Commercial/Multi-Family Design Review Committee

1. [26-0016](#) Review of plans for the commercial addition located at 610 Hagar/632 Rose Streets.

MEMORANDUM

SUBJECT: COMMERCIAL DESIGN REVIEW PROJECT
632 ROSE/610 HAGAR STREETS

SITE PLAN,
ENLARGED AREA
SITE PLAN AND
LOCATION PLAN

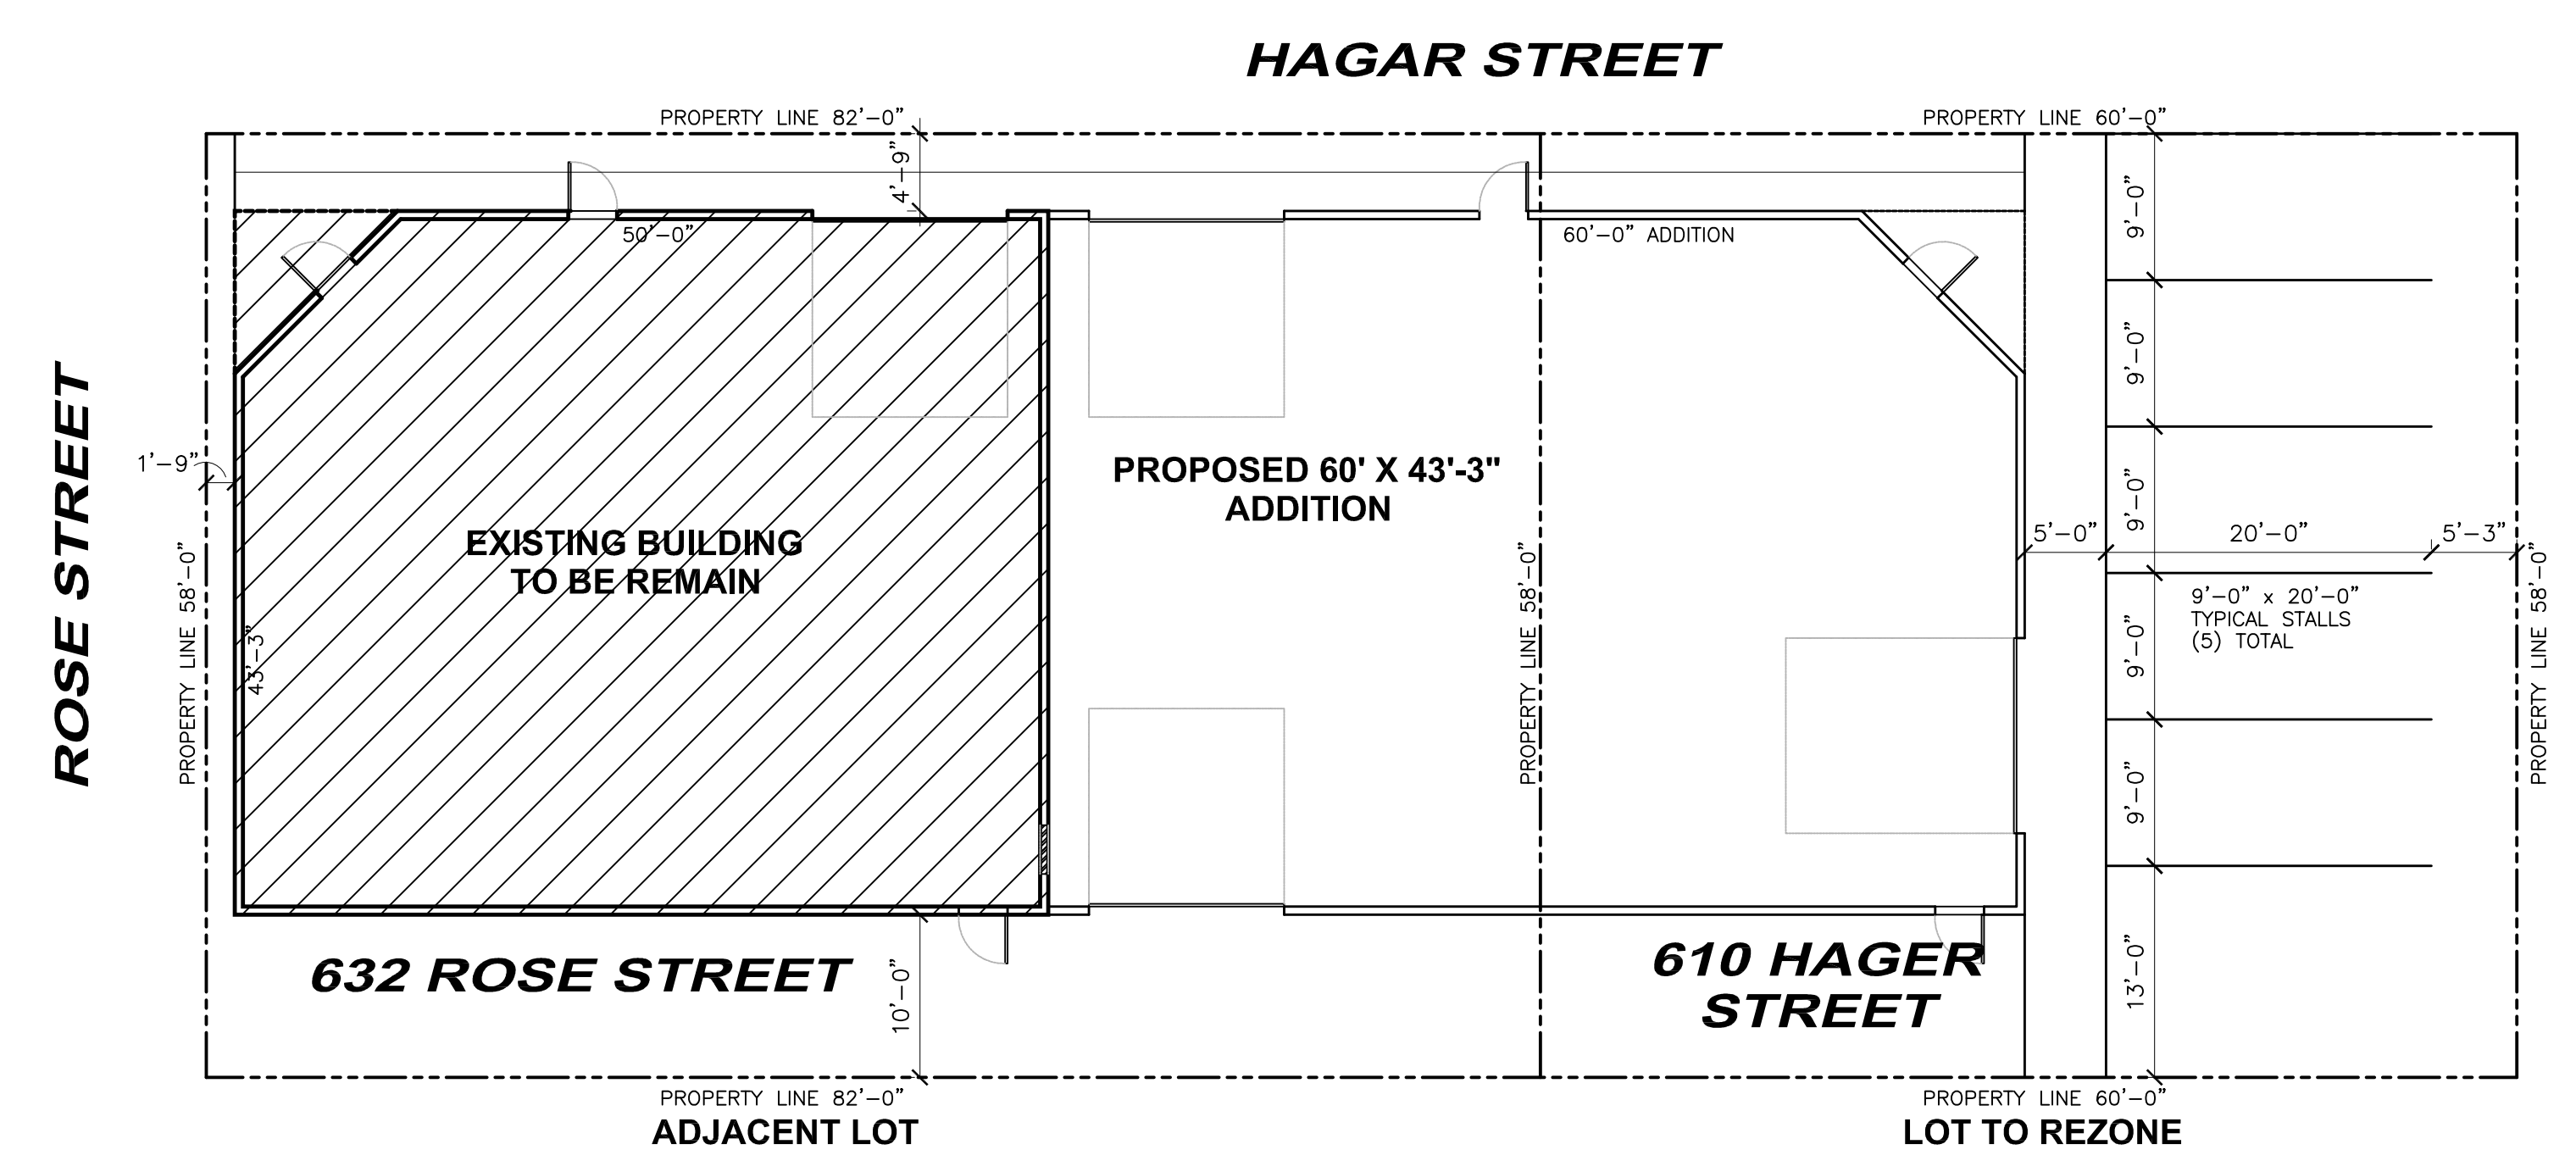
- 1) Must have lots combined before permits are issued. (Stephanie Sward)
- 2) Currently have four garage openings proposed. Will need to work with the Engineering Department to coordinate correct design specifications and process for all driveway openings and any replacement of public curb and sidewalk. (Stephanie Sward)
- 3) Parking lot needs barrier to prevent parking on Hagar Street sidewalk. (Stephanie Sward)
- 4) One parking space needs to be labeled ADA and include access aisle. (Stephanie Sward)
- 5) Need parking blocks to prevent parking over spaces onto the grass. (Stephanie Sward)
- 6)
- 7) Will need to submit a Photometric Plan. Include a summary of fixtures and model numbers used. Plan must also provide calculations/foot candles 25ft outside off of property lines. (Jamie Hassemer)

- 1) Would like stone veneer around building the whole building.
- 2) Non-Architectural metal is being proposed as a primary siding material. Work with staff on a different, permitted exterior material.
- 3) Link to Design Standards
 - a. <https://www.cityoflacrosse.org/home/showpublisheddocument/6084/637847479856030000>
- 4) Any exceptions to the design standards will need Common Council approval.
 - a. <https://www.cityoflacrosse.org/your-government/departments/city-clerk/forms-chart/request-for-exception-to-multi-family-housing-or-commercial-design-standards>

- 1) Area of combined lot is 8,120 sqft. No basement.
 - a. This project is exempt stormwater requirements.

- 1) Need Landscaping Plan.
